County of San Diego
Planning & Development Services
BUILDING DIVISION

ACCESSIBILITY CORRECTION LIST

Multifamily Housing

Doors and Gates

CBC FIGURE 11A-8A – FRONT APPROACH TO HINGED DOOR

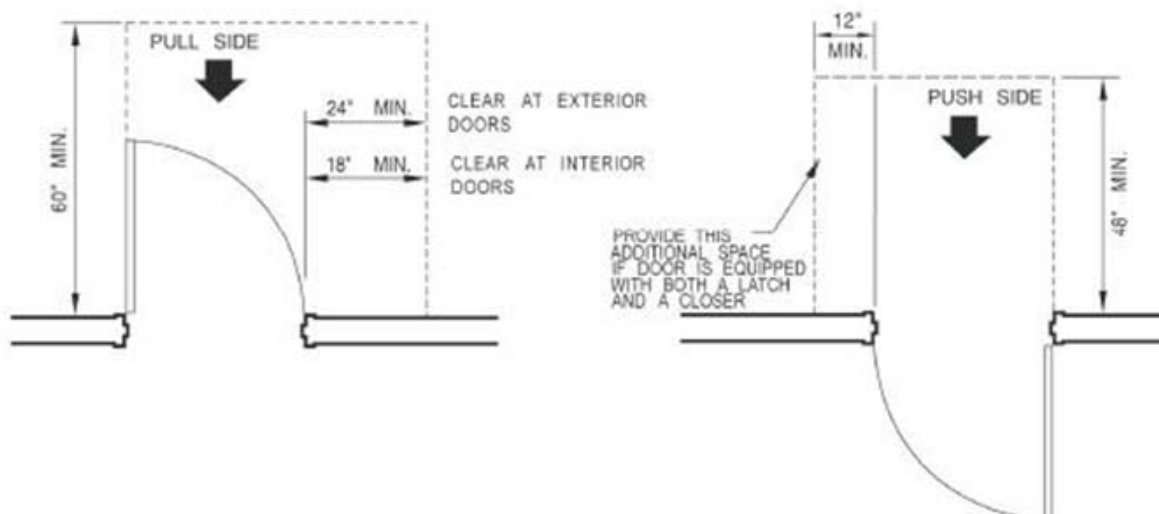
CBC 1126A.2
7. Dimension clear and level landings per CBC Figure 11A-8A for each hinged door requiring front approach:
 - ☐ Front approach to pull side of door:
 - o Width: Door width plus minimum 24 inches beyond latch side of exterior door and minimum 18 inches beyond latch side of interior door
 - o Depth: Minimum 60 inches perpendicular to doorway
 - ☐ Front approach to push side of door with latch and closer:
 - o Width: Door width plus minimum 12 inches beyond latch side of door
 - o Depth: Minimum 48 inches perpendicular to doorway
 - ☐ Front approach to push side of door without latch/closer combination:
 - o Width: Door width
 - o Depth: Minimum 48 inches perpendicular to doorway

CBC FIGURE 11A-8I – THRESHOLD

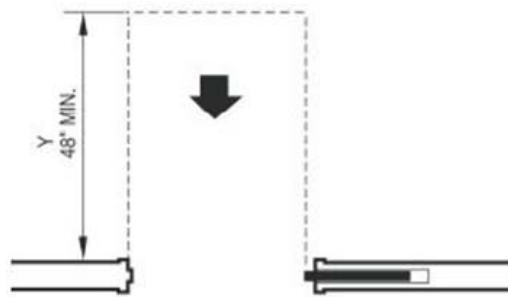
CBC 1126A.6
5. Detail door thresholds complying with the following per CBC Figure 11A-8I:
 - ☐ Maximum ½-inch change in level between landing and threshold
 - ☐ Maximum 1:2 beveled slope (50% gradient) for changes in level between ¼ inch and ½ inch

CBC FIGURE 11A-8D – FRONT APPROACH TO SLIDING/FOLDING DOOR

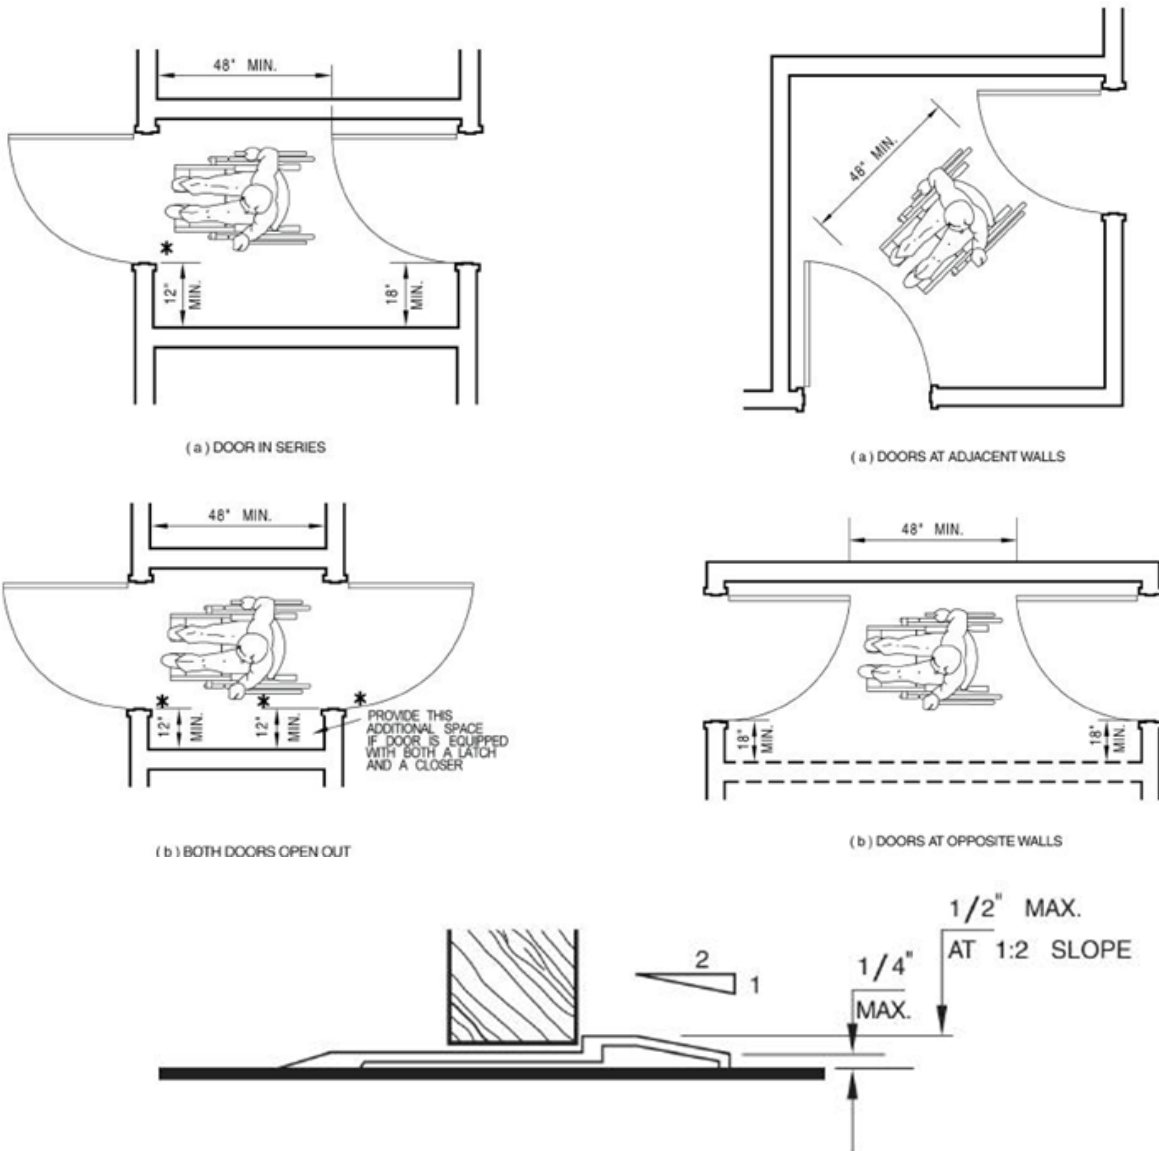
10. Dimension clear and level landings for each sliding or folding door:

- ❑ Front approach per CBC Figure 11A-8D:
 - Width: Door width
 - Depth: Minimum 48 inches perpendicular to doorway
- ❑ Slide-slide approach:
 - Width: Minimum 54 inches measured from latch side of door toward slide side
 - Length: Minimum 48 inches perpendicular to doorway
- ❑ Latch-side approach:
 - Width: Door width plus minimum 24 inches beyond latch side of door
 - Length: Minimum 44 inches perpendicular to doorway
